AIO Card ASIC Digital Noise Modification

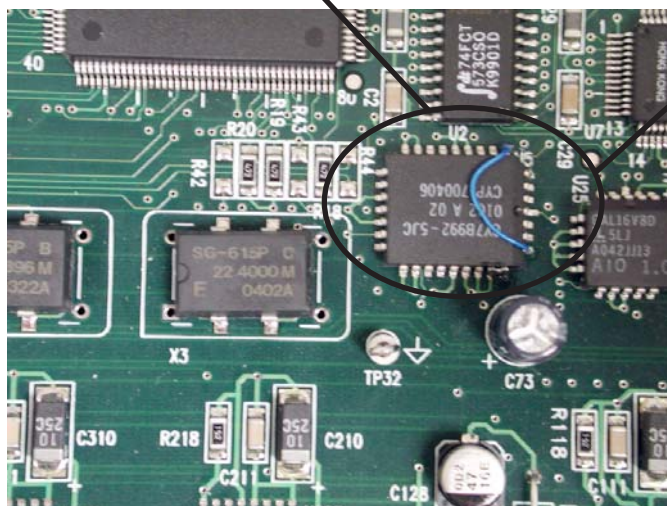
An audible “sizzling” or “frying” noise can be heard in port to port audio through the ADAM Matrix. This is more prevalent in end cards.

A timing problem exists in Telex TDM ASICs fabricated by AMI.

Changing the AIO card timing scheme to accommodate the increased delay needed by ASICs fabricated by AMI.

1. Using kynar or other suitable jumper wire, run a jumper from U5 pin 5 to U5 pin 30 as shown in the photo below.
2. Create a solder bridge between pins 28 and 29 on U5.

Note second line of text on ASIC starts with “AMI”.
